**PLANNING DIVISION REPORT
DEPARTMENT OF PLANNING AND COMMUNITY
AND ECONOMIC DEVELOPMENT
Of September 12, 2007**

RE: I.D. # 07500, Conditional Use Application – 1326 S. Midvale Boulevard

Engineering Statement
Prepared for the City of Madison
Re:
Proposed Verizon Wireless Tower Site #14-3650
1326 S. Midvale Blvd.
Madison, WI

**Engineering Statement
Prepared for the City of Madison
Re:
Verizon Wireless Tower Site #14-3650
1326 S. Midvale Blvd.
Madison, Wisconsin**

Figure 1 – Verizon Network Coverage Without Proposed Site

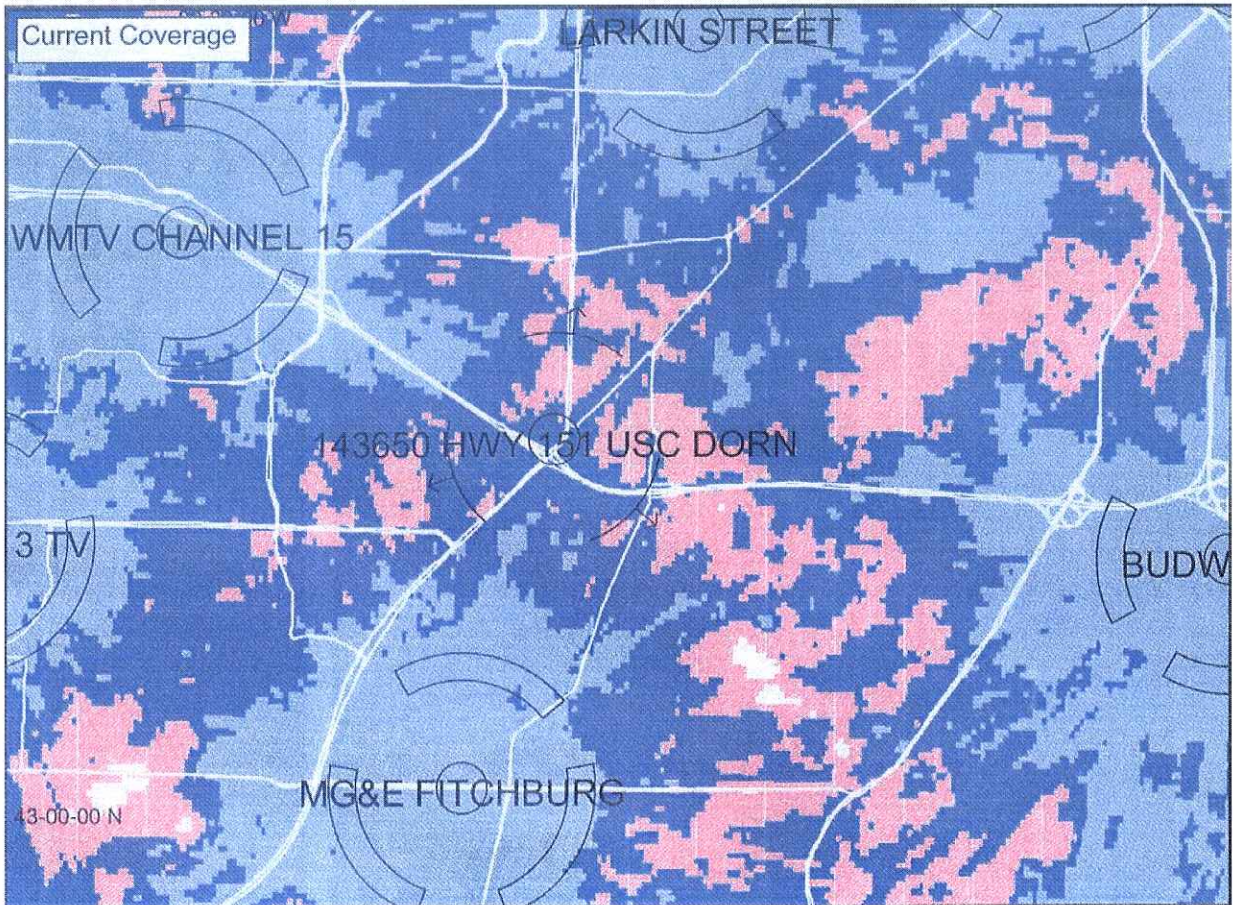
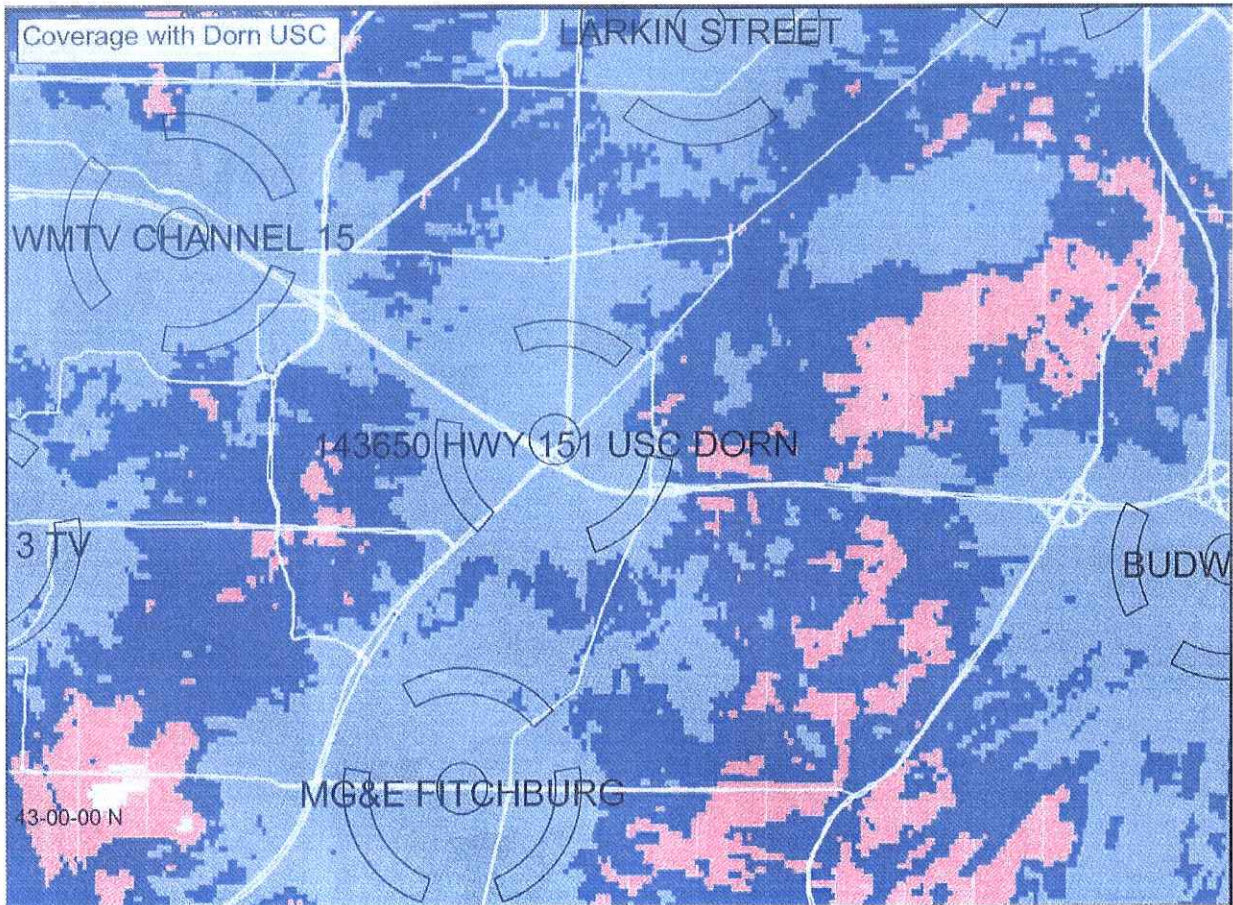
A propagation study conducted by Verizon Wireless, and verified by this consultant, shows the current and proposed coverage of the City of Madison. Figure 1, attached, shows the existing Verizon Wireless coverage in the area, while Figure 2 is a map of the Verizon Wireless coverage after the proposed site is activated.

There would be a substantial area that will be upgraded from "fair coverage" to "excellent coverage" as a result of the new site (see Figures 1 and 2). This site would assure continuous coverage in and around the local area and enhance service to a large number of area businesses by increasing call capacity in the area.

The proposed site is quite well positioned between the adjacent Verizon Wireless sites, as seen in the attached coverage maps.

Figure 3 – Antenna Structure Elevation Drawing

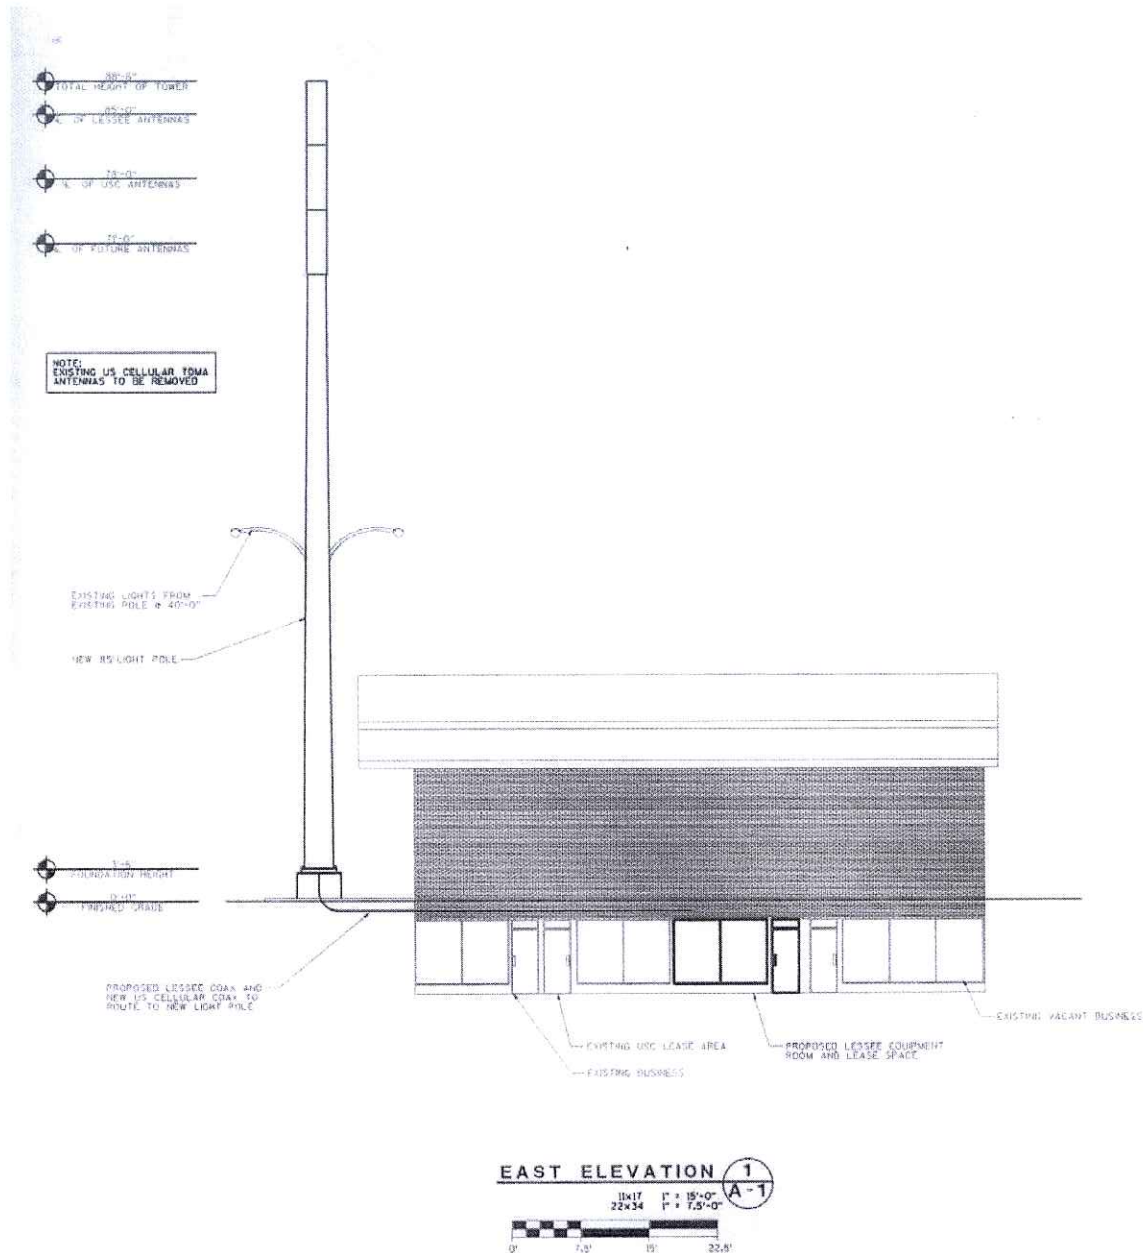
According to the elevation diagram, the proposed site will utilize a wireless antenna system housed within the light pole in enclosure jumpers, installed above 67 feet above ground and representing essentially omnidirectional coverage. The tower height proposed, 88'-6" AGL, has been requested by Verizon Wireless in order to adequately serve the area. The pole will be strong enough to support two additional carriers, at 78' (reserved for U.S. Cellular) and 71' AGL.

The proposed structure height of 88'-6" feet is, in the opinion of this affiant, the minimum that would be functional at this location. As a matter of fact, it may be difficult to attract the third co-locator for this site at the 71-foot level because of terrain and building attenuation.
